Connection Node Workshop

30 June 2022

Connection Node Requirements

Ion Pump Port

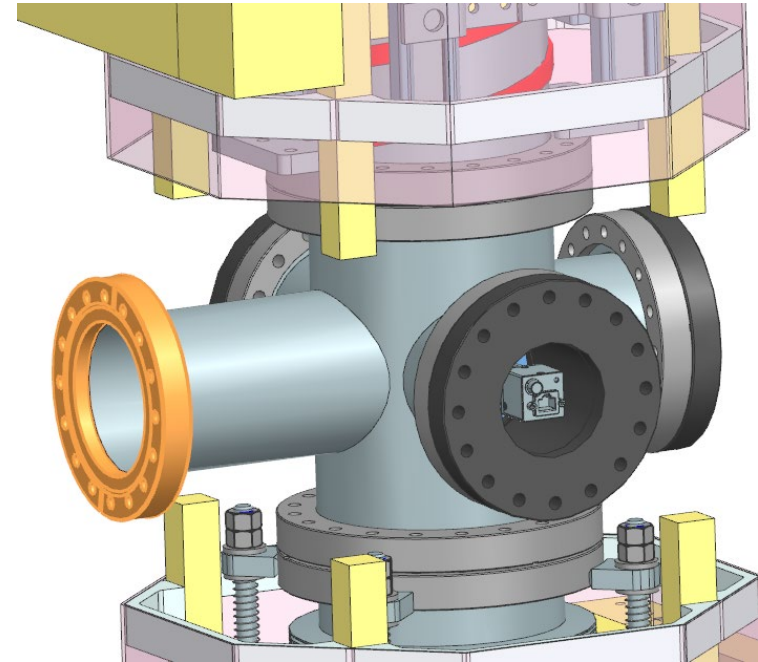
- 6" OD Flange (DN100CF)
 - Fixed or rotatable?
 - 4" tube max for bias coil interference
 - Suitable for vacuum requirements?
 - Could be elliptical tube to 8" OD flange
- Length not yet determined
 - Gauge connections?
 - Coupler size?
- Applied loads not yet confirmed
 - Ion pump weight pending
 - Support gusseting may affect assembly

Primary Vacuum Connection Ports

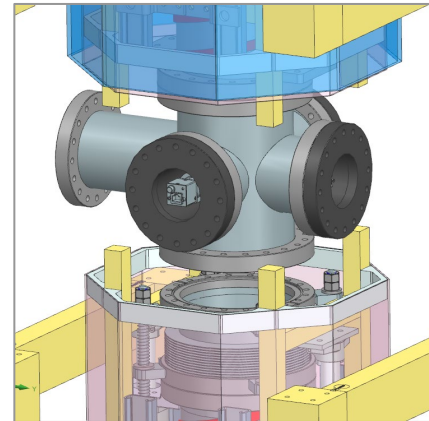
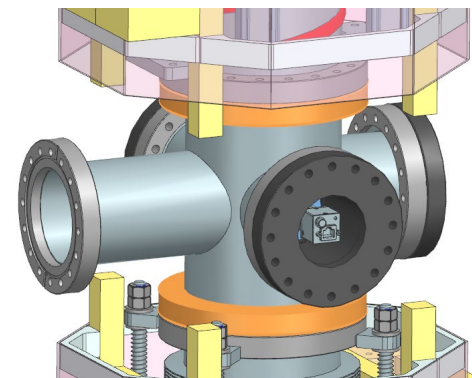
- 8" OD captive, rotatable flanges (DN160CF)
- Only lower flange made up in shaft
- Pipe length reasonably well defined
 - Sufficient clearance for fasteners
- Access issues remain for rear fasteners

Camera Ports

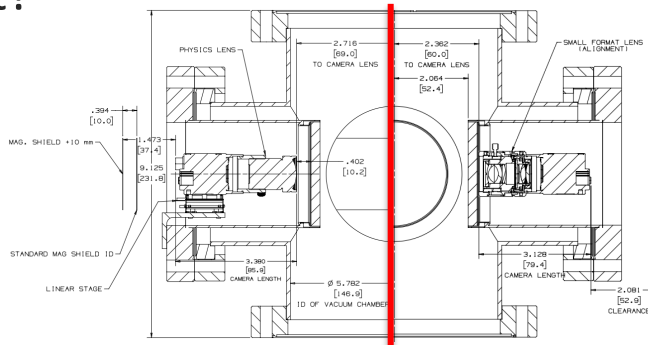
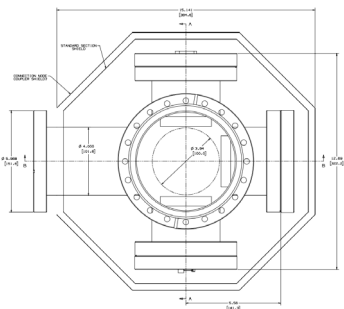
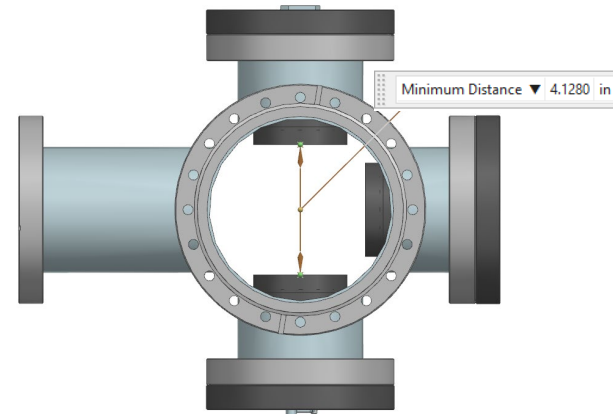
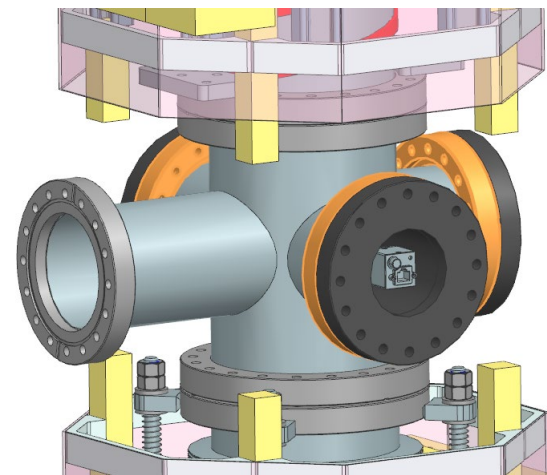
- 6" OD Fixed Flanges (DN100CF)
- Re-entrant flanges create 100mm clear aperture
- Flanges well-aligned to nominal cross axes
 - $\pm 1\text{mm}$ and $\pm 1^\circ$ of nominal position
- Length well defined by re-entrant flange length
- Camera lengths set?

Bellows Spool

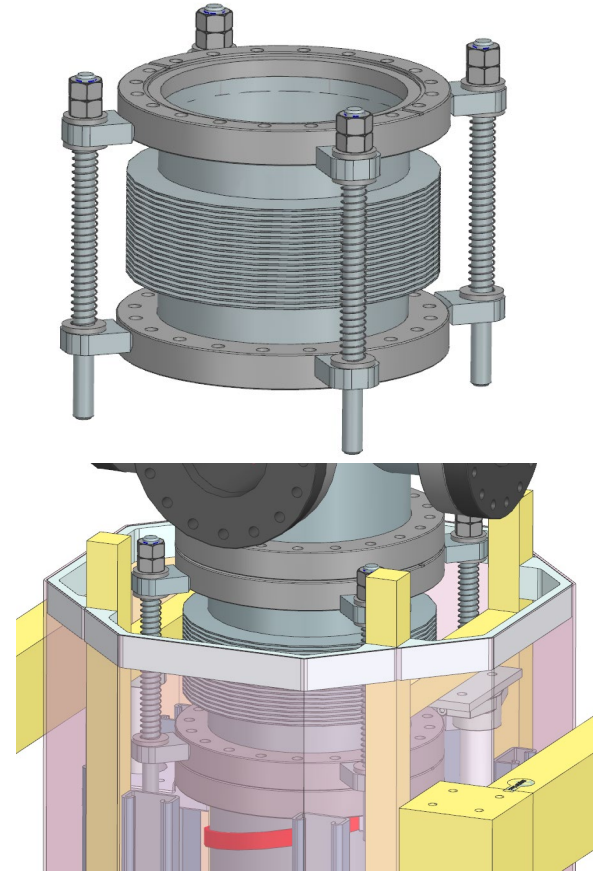
- $\pm 2''$ Travel (convolution count may not be accurate)
 - Bellows must be compressed during section installation
- Clearance for 1'' of insulation around bellows
- Spring loaded restraint features
 - Easy restraint disengagement from basket
 - Additional nuts added for horizontal section assembly
- Welded tab construction
 - Single piece machined construction being investigated

Cross Construction Methods

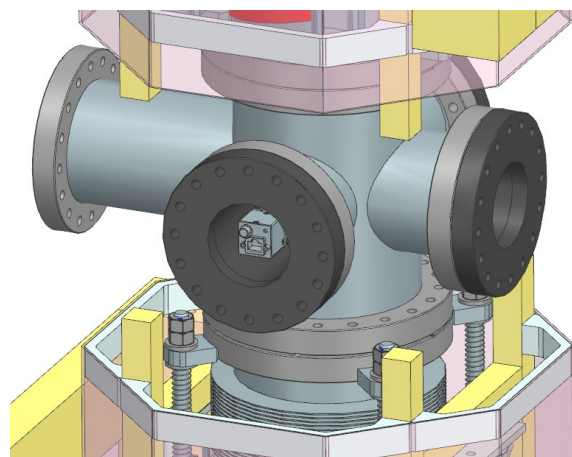
- \$3,750 DN160CF/ \$2,120 DN100CF
- Though or tapped holes in fixed or rotatable flanges possible
- Potential bracing for ion pump needed
- Rotatable flanges or flange clocking required

- More accurate camera placement
- Well defined flange orientations
- Custom cubes may be heavy/expensive
- Possible bellows restraint interference
- Tapped holes only
- \$6,185 DN160CF (+\$40k)/ \$3,250 DN100CF (+\$20k)

Hybrid cube with welded upper, lower, and ion pump ports?

Ion Pump Orientation

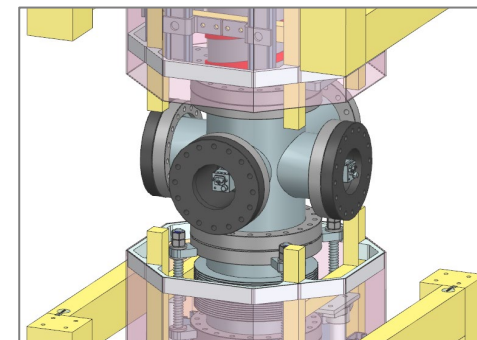
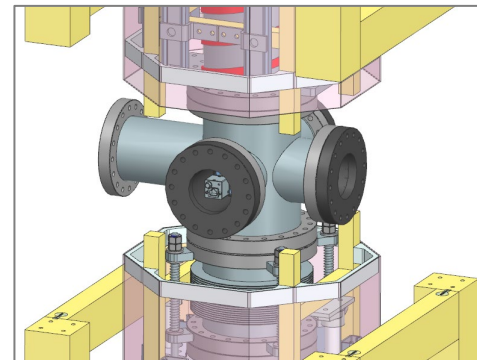
- Easier access from shaft for maintenance/repair
- Significant access issues to rear camera
- Ion pump harder to install when section is horizontal

- Improved camera access
- Ion pump arrangement matches atom source connections
- Easier to install ion pump when section is horizontal
- No access to ion pump after section is installed

*Impact of either arrangement on installation is unclear

Laser Safety

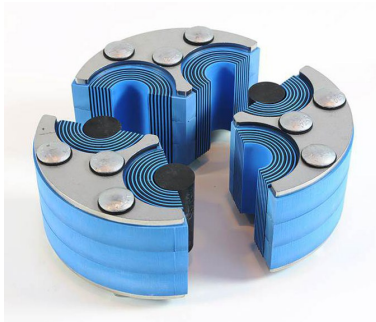
- Lasers may escape through viewports
- Cross must be light-tight
 - Making shielded regions light tight not feasible
- Thin cable seal needed
 - Significant space limitations
